LAKE PONTCHARTRAIN, LOUISIANA AND VICINITY
CHALMETTE AREA PLAN

**BAYOU BIENVENUE CONTROL STRUCTURE
PERIODIC INSPECTION REPORT NO. 8**

CEMVD-ET-EG (CEMVN-ED-GE/9 Aug 99) (11-2-240a) 3d End
Stagg/ts/5644
SUBJECT: 1999 Periodic Inspection No. 8 for Bayou Bienvenue
Control Structure

SUBJECT: 1999 Periodic Inspection Report No. 8 for Bayou Bienvenue Control Structure

PHOTO NO. 16 – DOUBLE DRUM HOIST USED TO OPEN AND CLOSE GATE SECTOR.

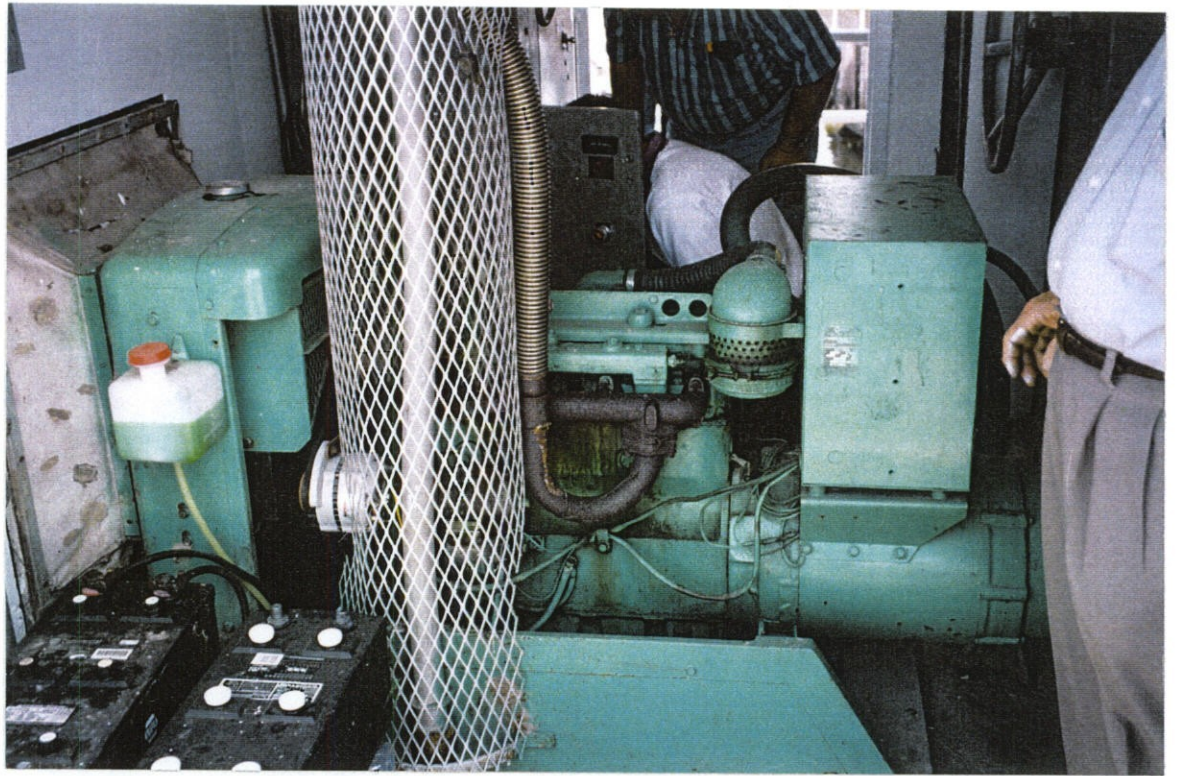
a. Paragraph 5-03e(2) Page V-6 and Paragraph 6-02d(2) Page VI-2. The referenced paragraph on page V-6, states that the "sand or grit" observed on the mechanical equipment should be removed to prevent damage to the equipment. We concur in this proposed action, and although the paragraph did not specifically state it, it was also assumed that this action would proceed as soon as possible, since sand in a bearing assembly (ball bearings, bronze bushings, etc.) is not a desirable condition. However, the referenced paragraph on page VI-2, indicates that the equipment may not be cleaned for as long as several months. Therefore, paragraph 6-02d(2) should be revised to say that the abrasive materials will be removed from the operating equipment without delay.

a. Paragraph 5-03e(2) Page V-6 and Paragraph 6-02d(2) Page VI-2. Concur. The Orleans Levee District has been notified that the abrasive material needs to be removed from the operating machinery as soon as possible. Paragraph 6-02d(2) has been revised accordingly. See enclosure 4.
